SERVICE BULLETIN

APPLICABILITY: 2013-14MY Impreza 2.0L NA Models
 2013-14MY XV Crosstrek, Including Hybrid Model (HEV)

NUMBER: 11-149-14R
DATE: 11/06/14
REVISED: 04/06/15

SUBJECT: Reprogramming File Availability for Oil Level Detection

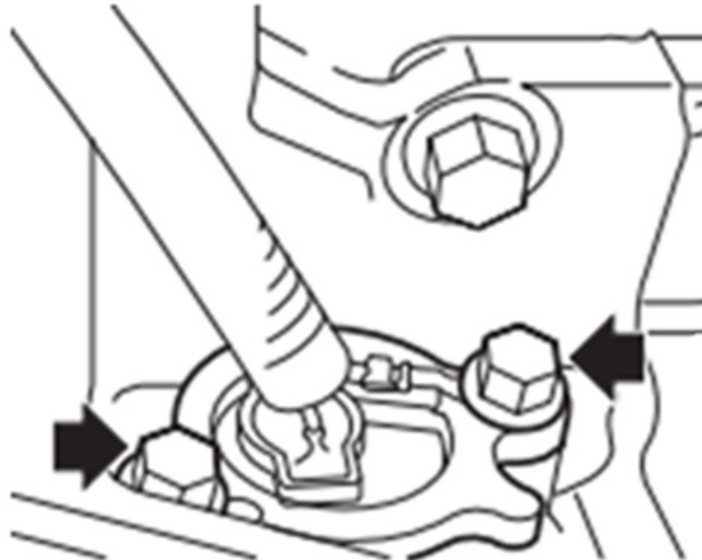
Step 3 - Once the ECM reprogramming has been completed and the oil level switch wiring has been confirmed to be OK, proceed with replacing the oil level switch assembly shown in the illustration below following the procedure outlined in the applicable Service Manual. Torque the 2 retaining bolts to 6.4 Nm (56 inch-pounds). Torque the 2 retaining bolts to 6.4 Nm (56 inch-pounds).
